MODEL  
2020-2021MY  
Telluride (ON)

NUMBER  
231

## TECHNICAL SERVICE BULLETIN

**FRONT VIEW CAMERA REPLACEMENT  
FOR DTC C160449 & C160649**

Front View Camera

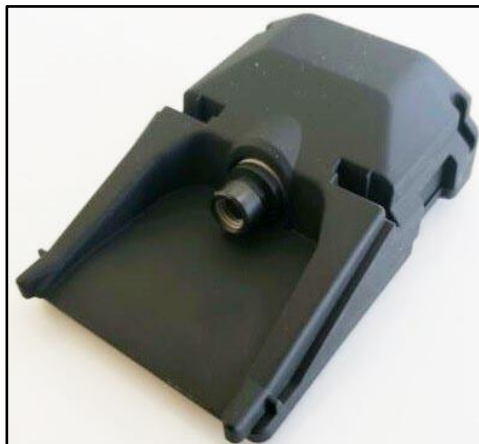
This bulletin provides information on the inspection and replacement of the front camera on some 2020-2021MY Telluride (ON) vehicles, produced from August 7, 2018 through November 30, 2020. Due to an internal control chip concern inside the camera, the vehicle may exhibit an MIL on with DTC C160449 and/or C160649, as well as illumination of the Smart Cruise Control (SCC), Lane Keep Assistance (LKA), Lane Departure Warning (LDW), Forward Collision-Avoidance Assist (FCA), Forward Collision Warning (FCW) and/or Driver Attention Warning (DAW) lights. These systems may become temporarily disabled during occurrences. Follow the procedure outlined in this publication to diagnose and replace the front view camera assembly.

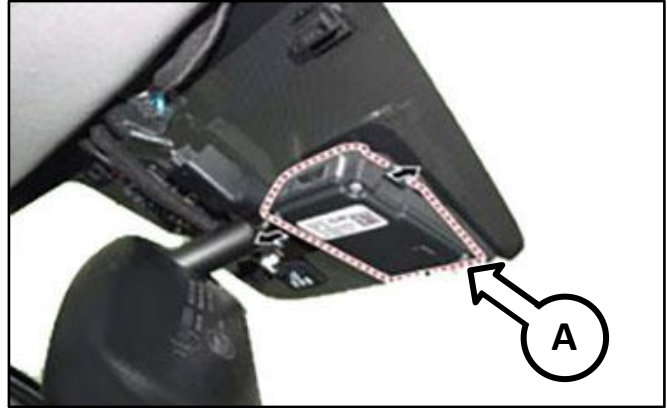
- 1a. Remove and replace the Front View Camera (A) by referring to the “Body Electrical System → Front Camera System → Front View Camera Unit → Repair Procedures” chapter in the applicable Shop Manual on KGIS.

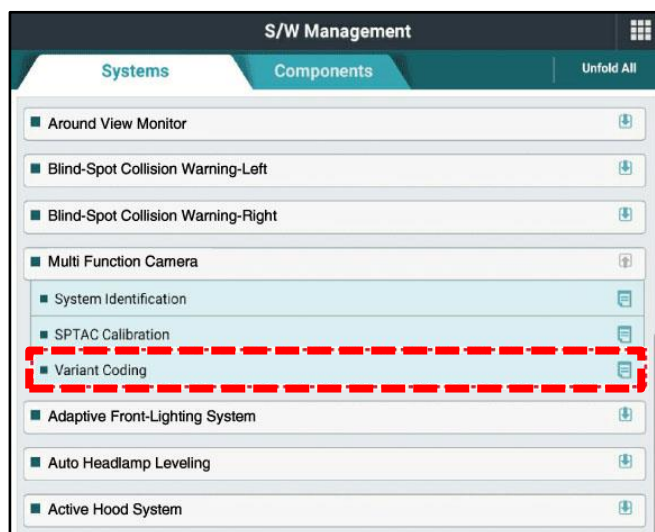
- 1b. Confirm the lot numbers of the new units as shown. Manufacturing date code is “YYMMDD”.

- **Telluride (ON):** Improved Lot is from June 7, 2019 and later.

Lot No. 200122 = Mfg. date 2020-01-22 (January 22, 2020)
